Final Land Use Control Implementation Plan, Area of Contamination 57

**Former Fort Devens Army Installation
Devens, Massachusetts**

September 2023

**Figure
 2**

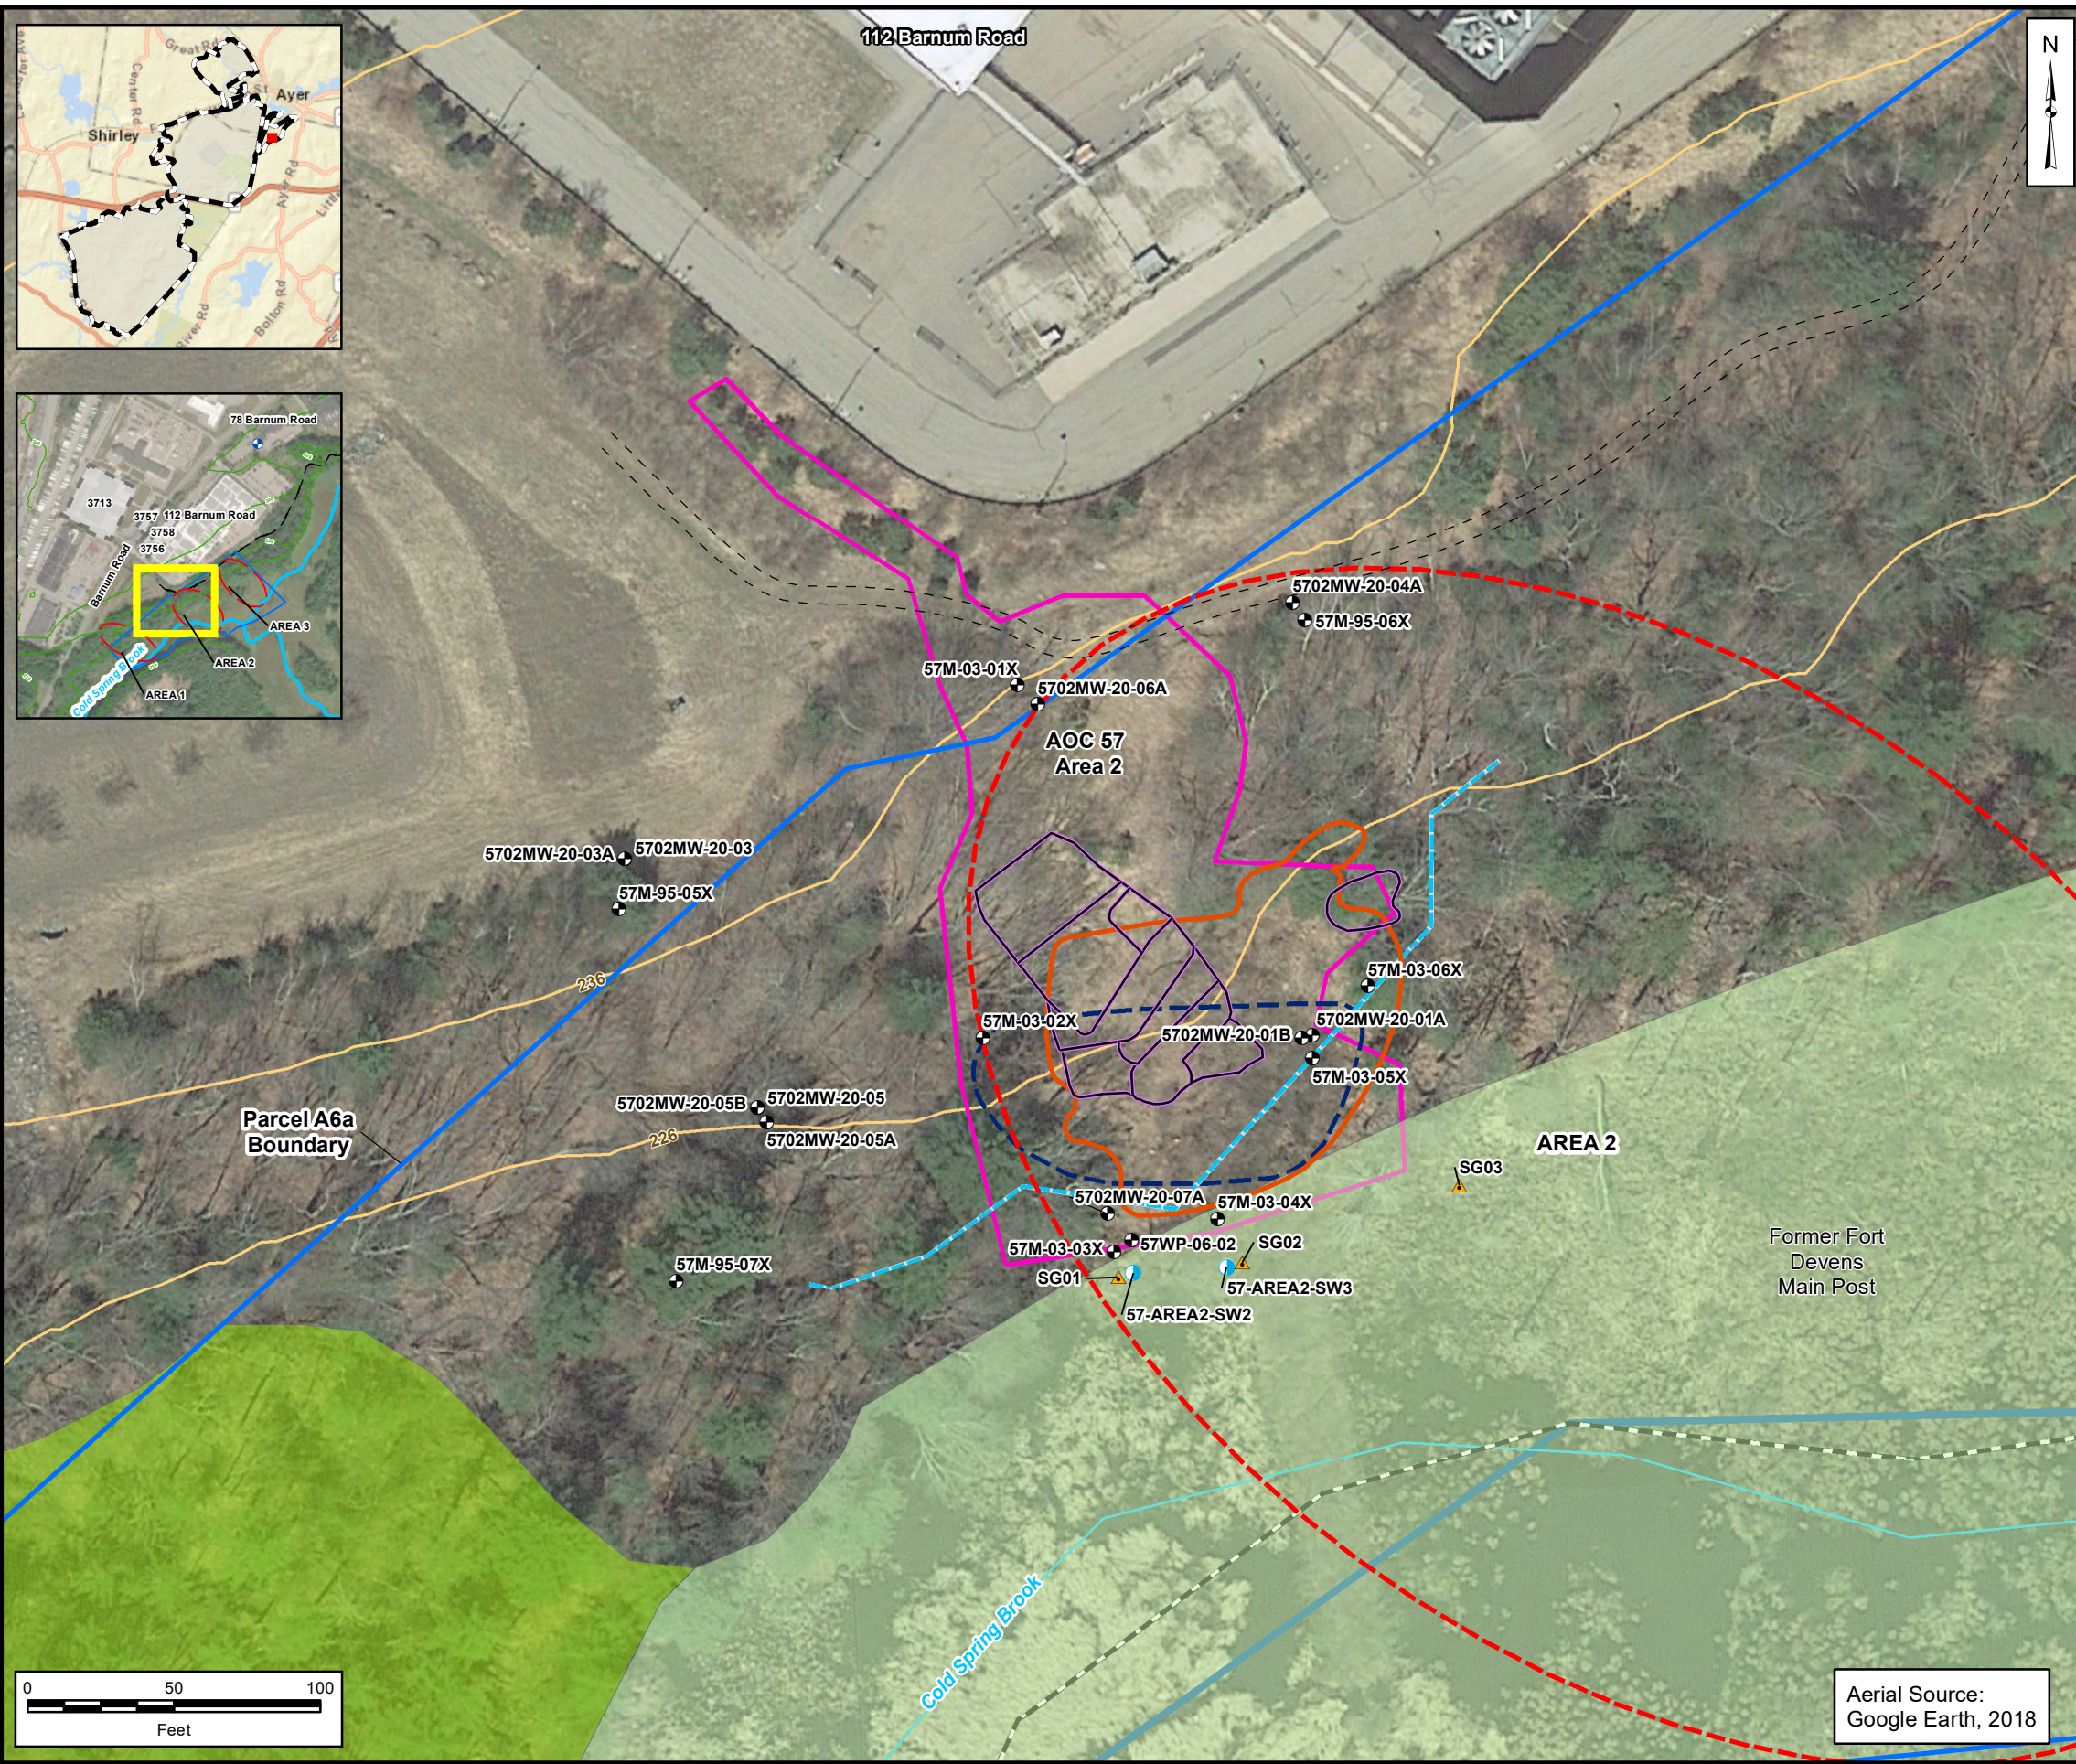
| No. | Ref. Page / Para. | COMMENT (MassDEP submitted on September 14, 2022 and USEPA submitted on September 30, 2022) | RESPONSE (Submitted on November 17, 2022 as a Response Letter to MassDEP/USEPA Comments on the Draft) | BACKCHECK COMMENT (MassDEP submitted on December 6, 2022 and USEPA submitted on December 5, 2022) | BACKCHECK RESPONSE |
|-----|---|--|--|--|--|
| 18. | Page 13, Table 2, "Area of Interest Column," Figure 2 | Please amend or replace the existing figure to show the boundaries for each of the ICs/LUCs placed on the property, as described in the AOC 57 ROD, ESD and FOST. This would make it extremely clear what the restrictions are and that they satisfy the objectives set forth in this table (See GC 2.) | Figure 2 will be revised in response to this comment and will also be revised to show the parcel boundary as presented in the ROD (Parcel A.6A). | NA | NA |
| 19. | Page 13, Table 2, "Area of Interest" Column, Figure 2 | Please amend or replace the existing figure to identify/demark the Parcel boundaries shown in the September 2015 FOST, "Enclosure 1 – Site Map of Property." (See Page-Specific Comment (PSC) 13.) | Figure 2 will be revised to show the parcel boundary as presented in the ROD (Parcel A.6A). | NA | NA |
